PROJECT
THREE STOREY RESIDENTIAL FLAT BUILDING
WITH BASEMENT CAR PARK AT:
**5 COMMONWEALTH PDE,
MANLY, NSW**

DRAWING TITLE			PROJECT
SITE ANALYSIS PLAN			CPM
SCALE	STATUS	NUMBER	REVISION
1:500 @A3	s4.55	A0.01	s4.55

LIST OF AMENDMENTS

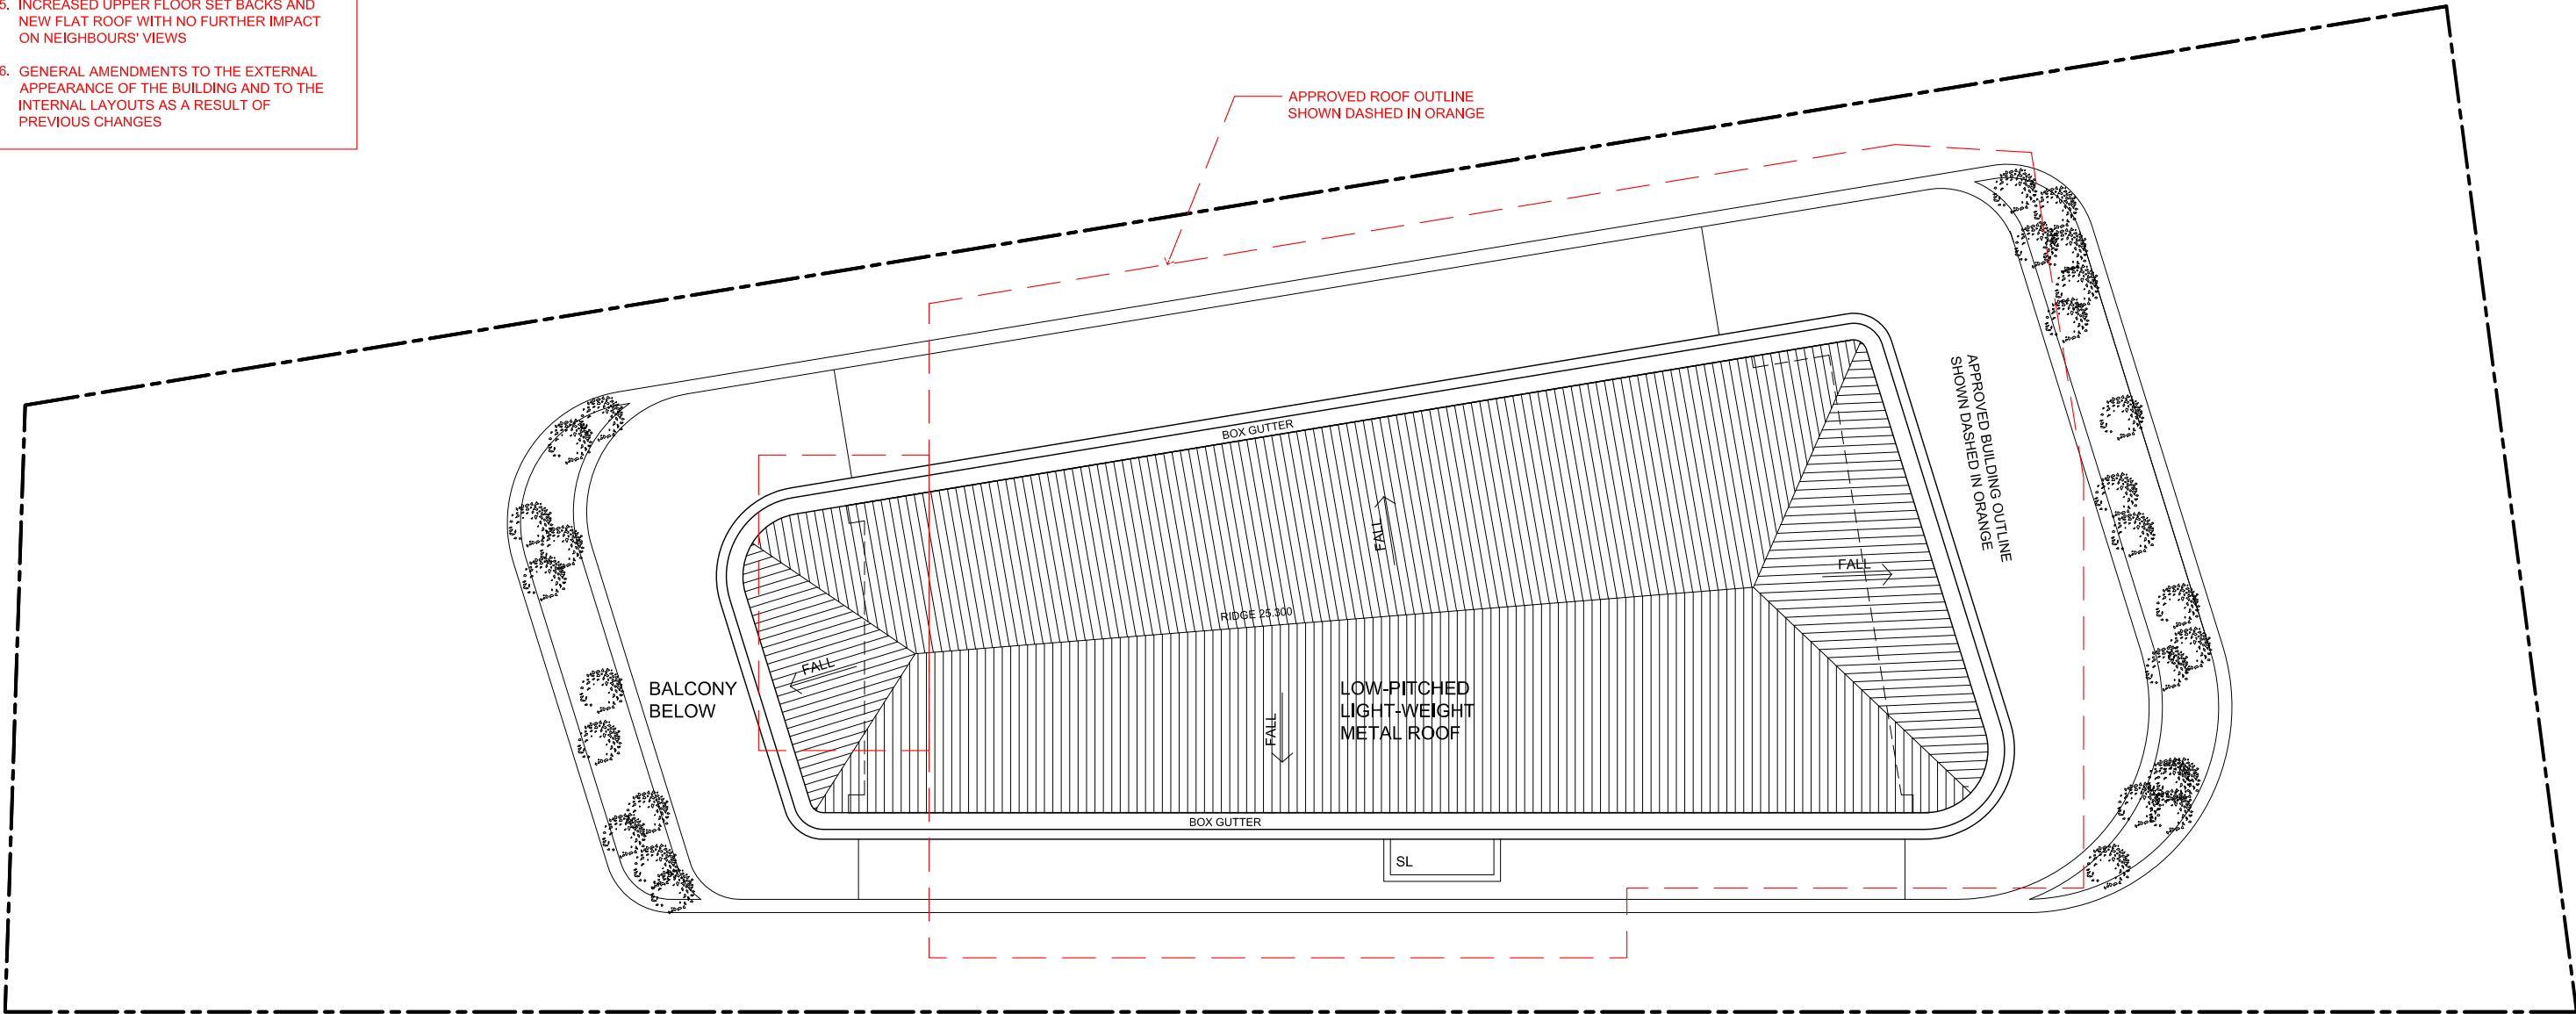
1. PREVIOUS SURVEY WAS NOT SET OUT TO AHD, ALL RLS ADJUSTED TO SUIT NEW SURVEY
2. ADJUSTMENTS TO RAMP AND CAR STACKER TO COMPLY WITH REGULATIONS & AS2890.1
3. GREENERY & PRIVACY TREATMENTS INCORPORATED INTO THE BUILDING DESIGN TO ADDRESS PRIVACY AND IMPROVE AMENITY
4. RECONFIGURATION OF THE CORE
5. INCREASED UPPER FLOOR SET BACKS AND NEW FLAT ROOF WITH NO FURTHER IMPACT ON NEIGHBOURS' VIEWS
6. GENERAL AMENDMENTS TO THE EXTERNAL APPEARANCE OF THE BUILDING AND TO THE INTERNAL LAYOUTS AS A RESULT OF PREVIOUS CHANGES

ROOF PLAN

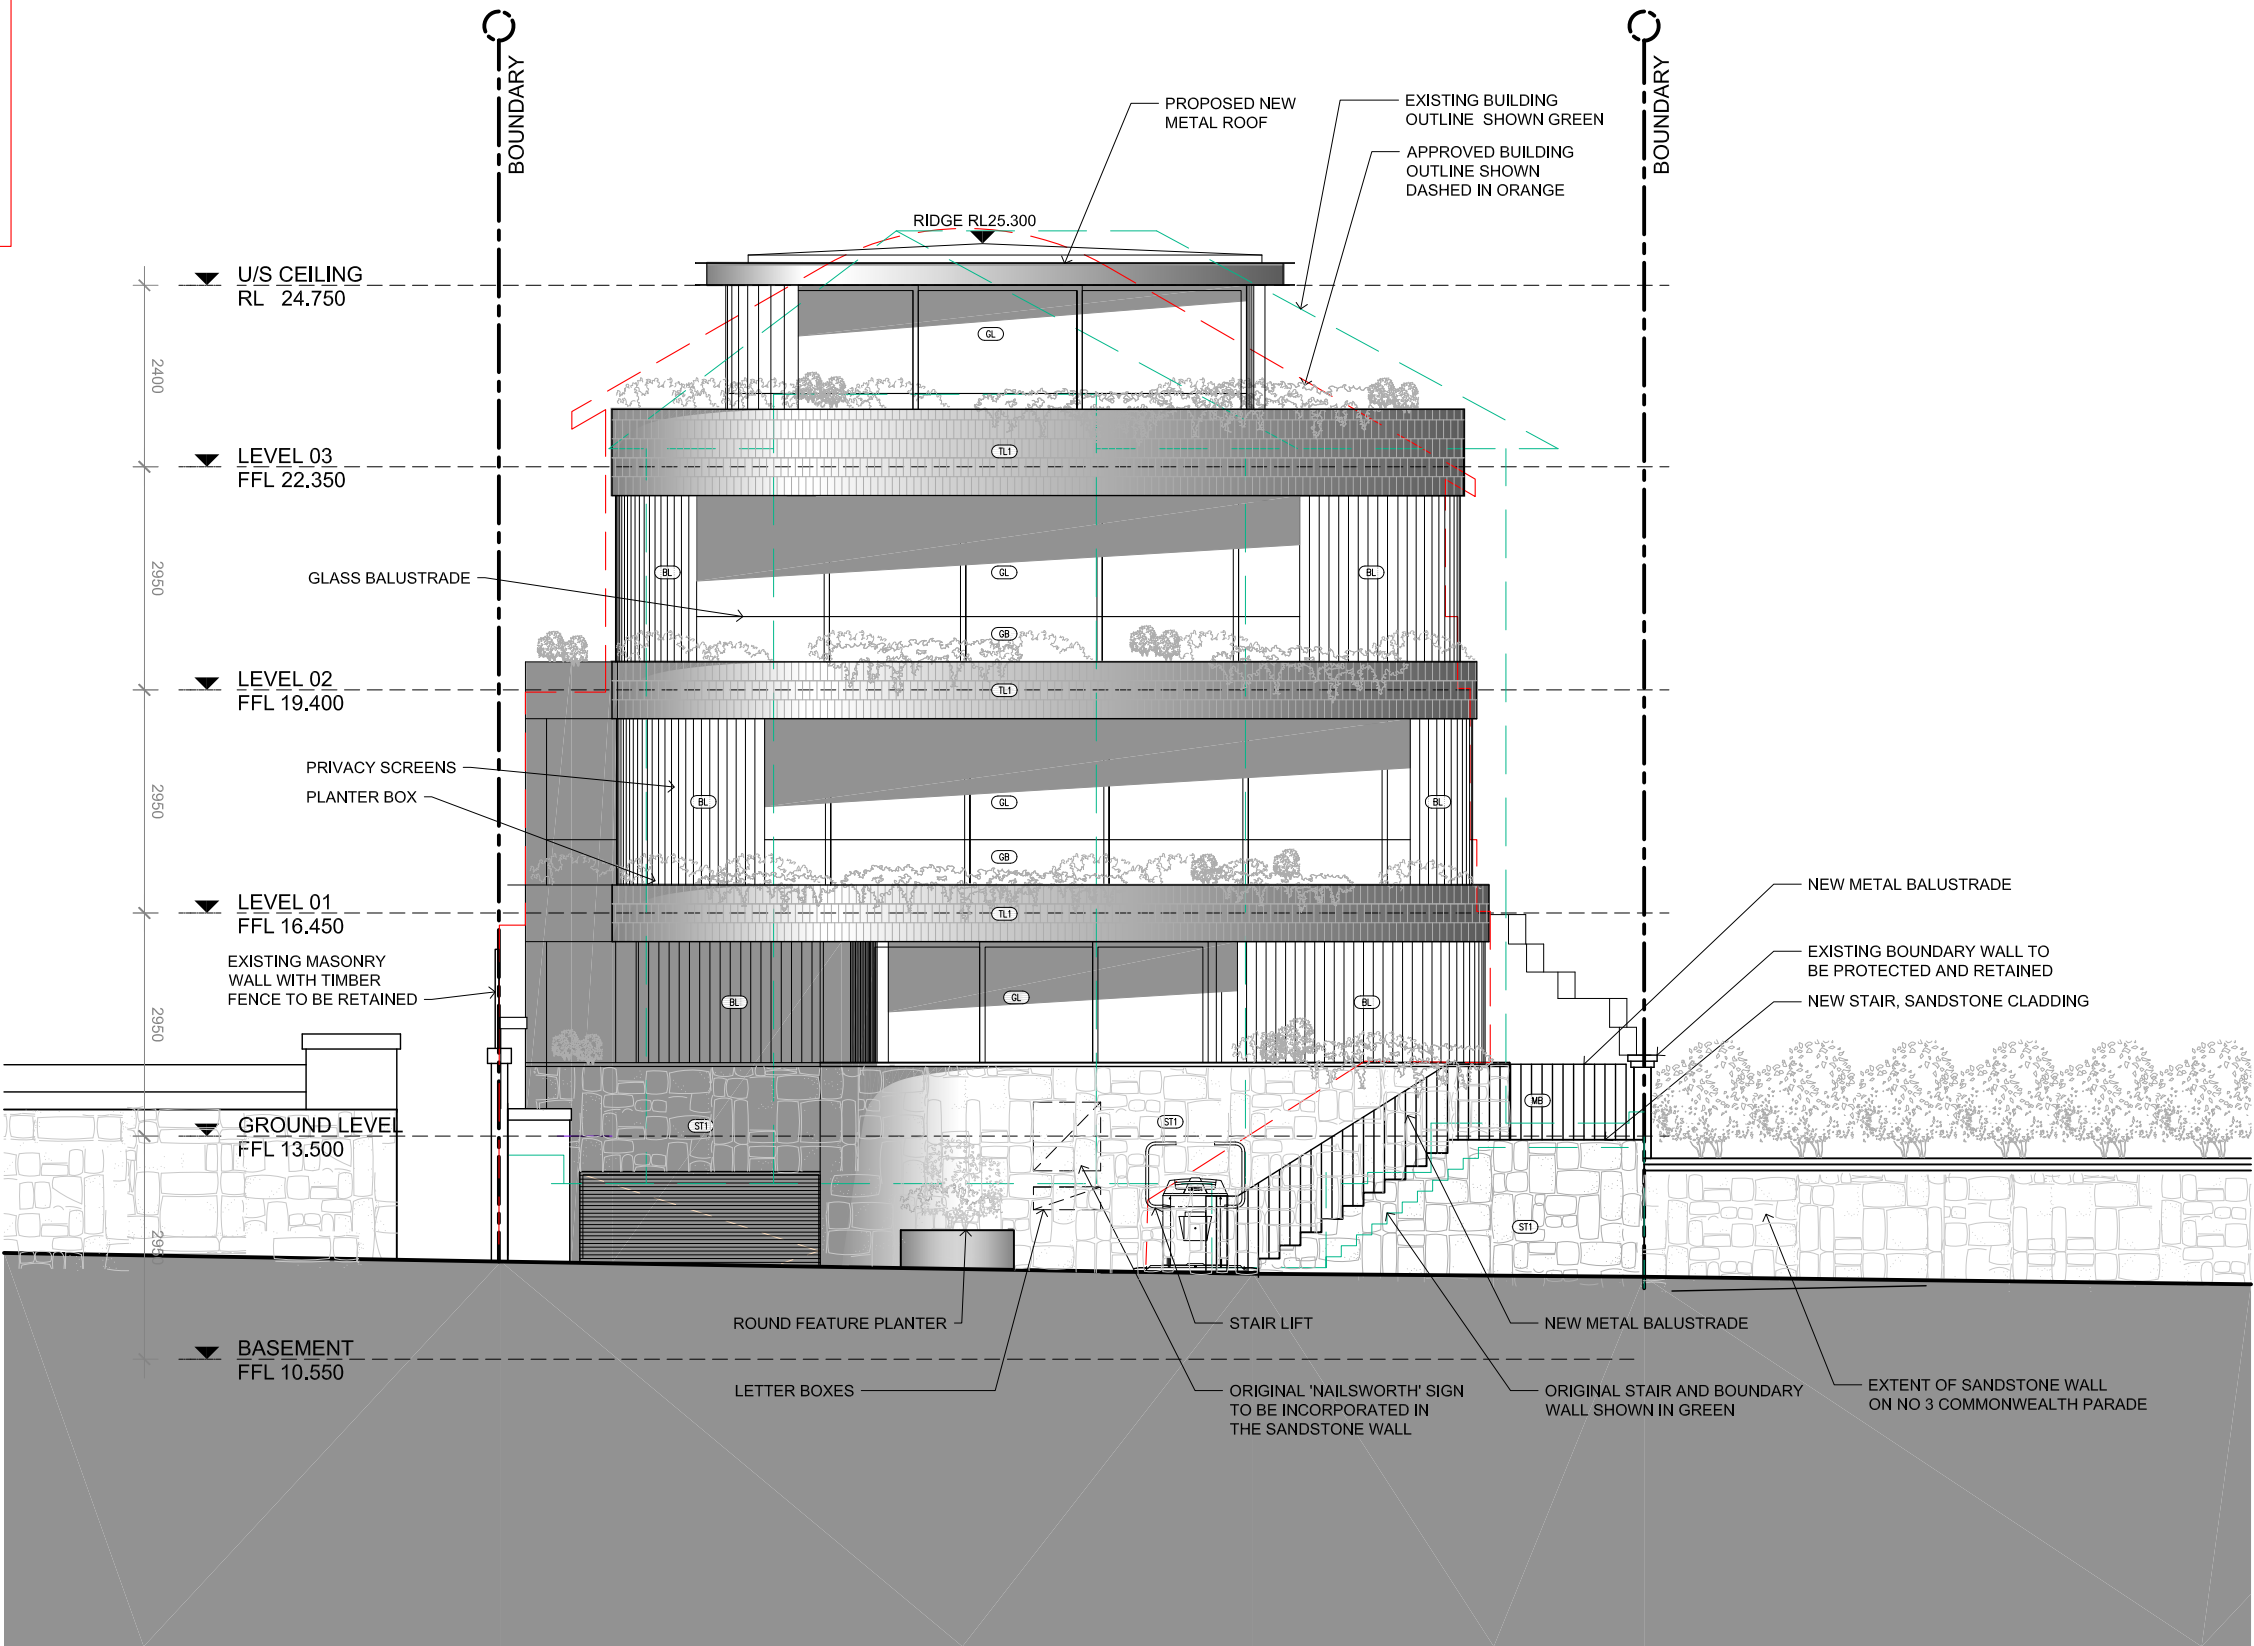
1. ADJUSTMENTS TO RAMP AND CAR STACKER TO COMPLY WITH COUNCIL CONDITIONS
2. GREENERY & PRIVACY TREATMENTS INCORPORATED INTO THE BUILDING DESIGN TO ADDRESS PRIVACY AND IMPROVE AMENITY
3. RECONFIGURATION OF THE CORE TO MAKE IT MORE EFFICIENT
4. THE CURVED ROOF IS REPLACED WITH A LIGHT-WEIGHT FLAT ROOF
5. GENERAL AMENDMENTS TO THE EXTERNAL APPEARANCE OF THE BUILDING AND TO THE INTERNAL LAYOUTS AS A RESULT OF PREVIOUS CHANGES

DRAWING TITLE
EAST ELEVATION

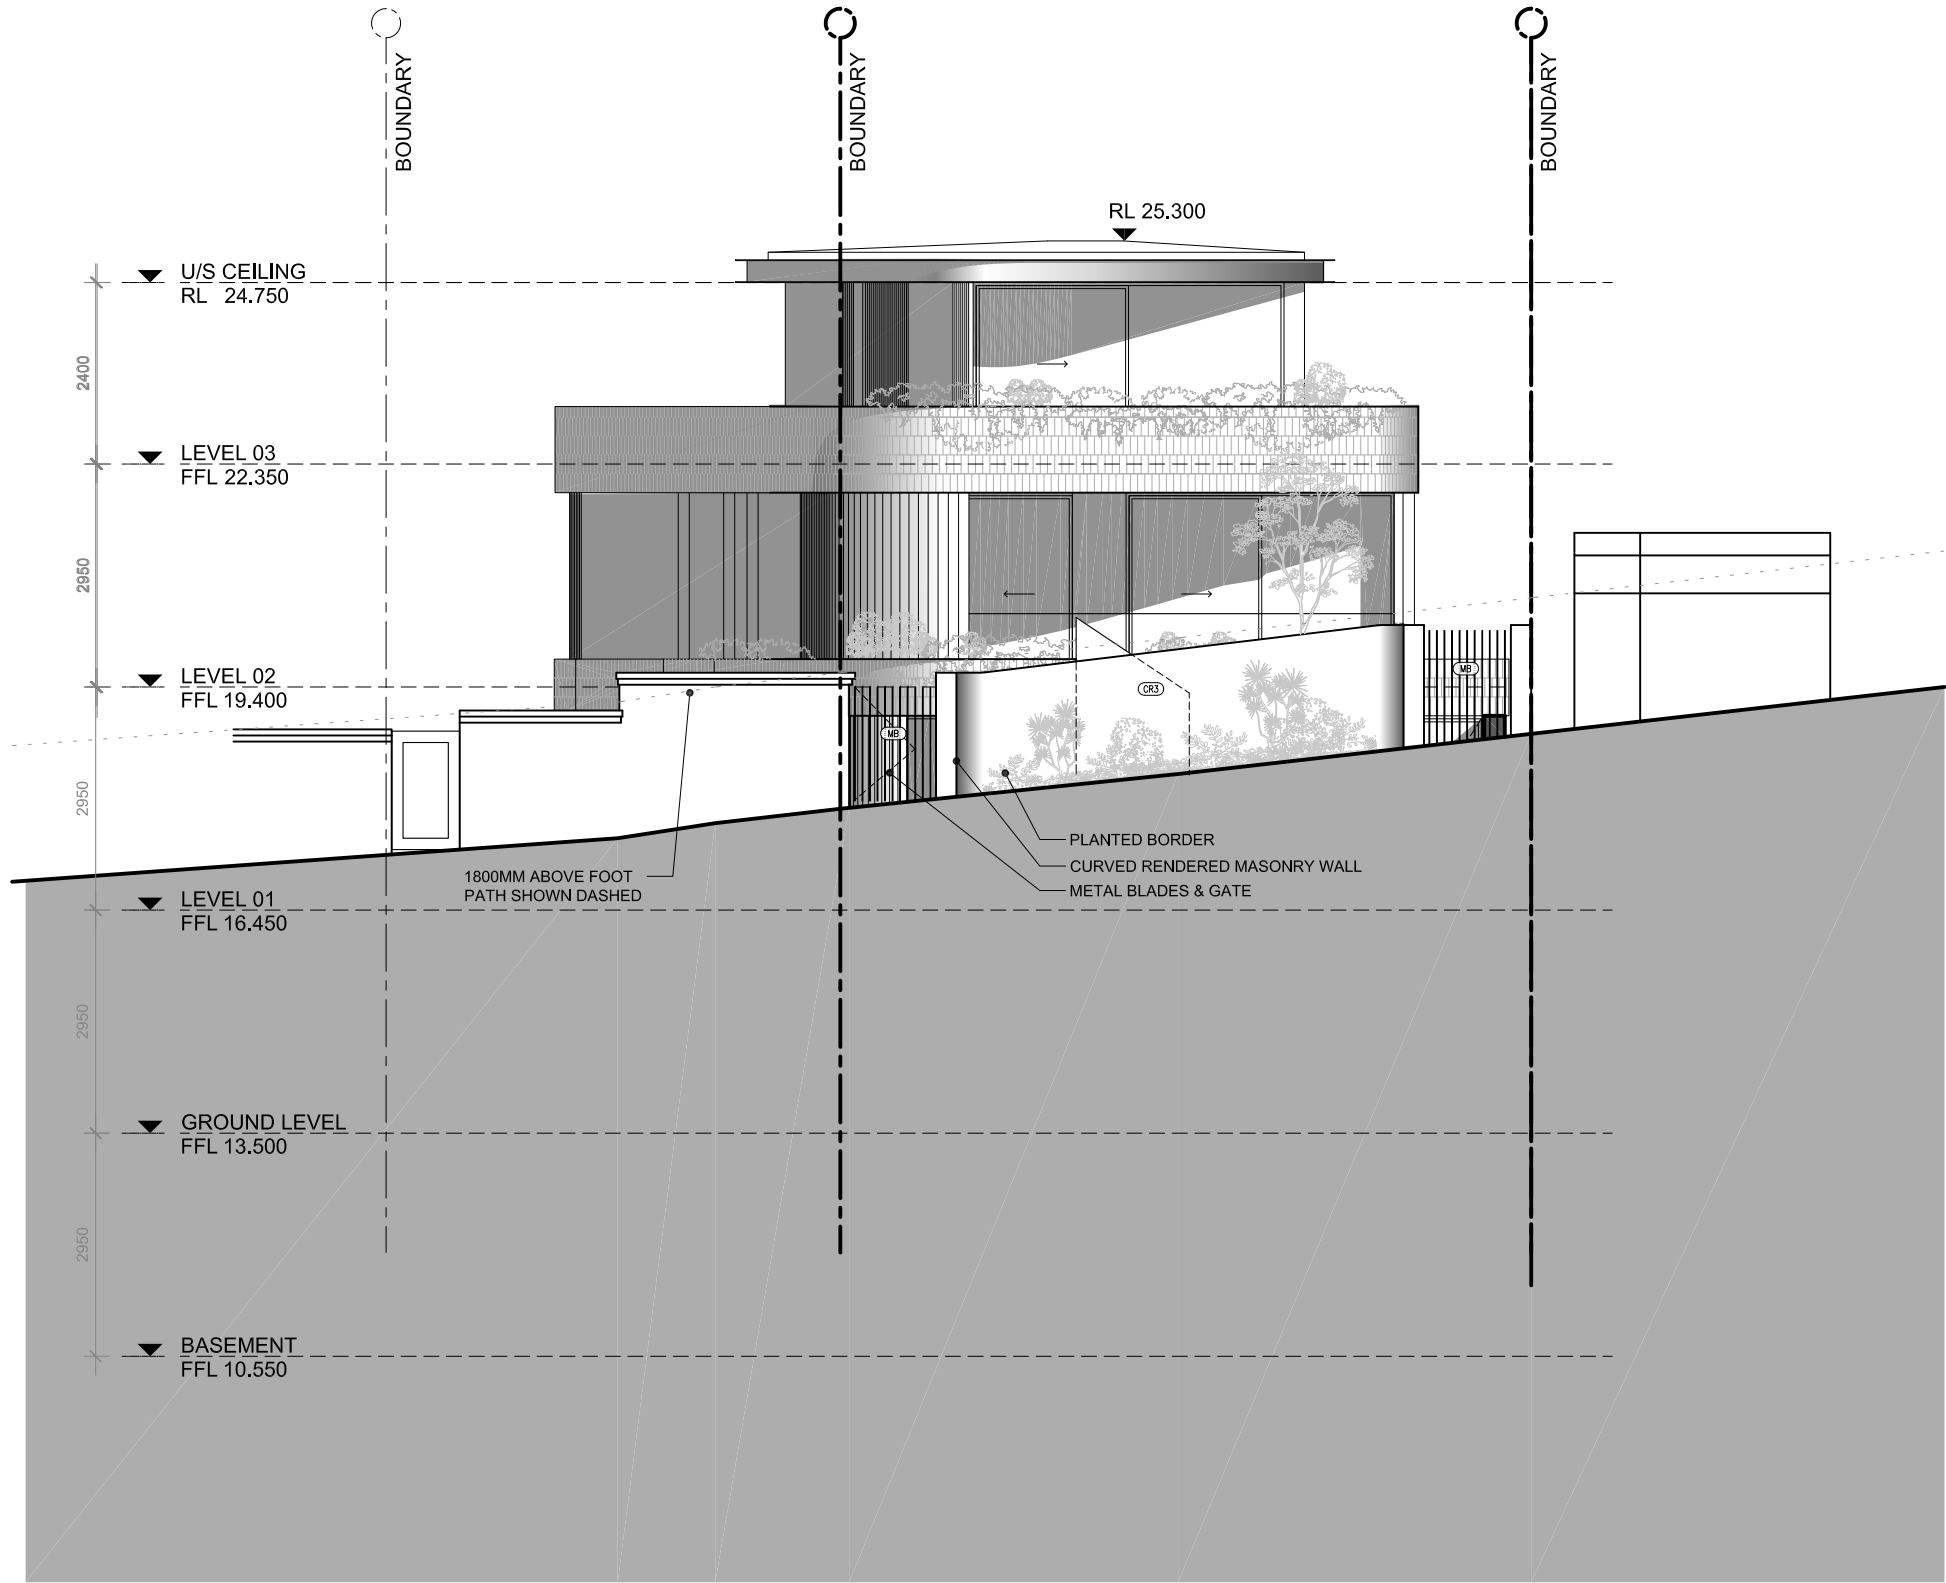
- PREVIOUS SURVEY WAS NOT SET OUT TO AHD, ALL RLS ADJUSTED TO SUIT NEW SURVEY
- ADJUSTMENTS TO RAMP AND CAR STACKER TO COMPLY WITH REGULATIONS & AS2890.1
- GREENERY & PRIVACY TREATMENTS INCORPORATED INTO THE BUILDING DESIGN TO ADDRESS PRIVACY AND IMPROVE AMENITY
- RECONFIGURATION OF THE CORE
- INCREASED UPPER FLOOR SET BACKS AND NEW FLAT ROOF WITH NO FURTHER IMPACT ON NEIGHBOURS' VIEWS
- GENERAL AMENDMENTS TO THE EXTERNAL APPEARANCE OF THE BUILDING AND TO THE INTERNAL LAYOUTS AS A RESULT OF PREVIOUS CHANGES
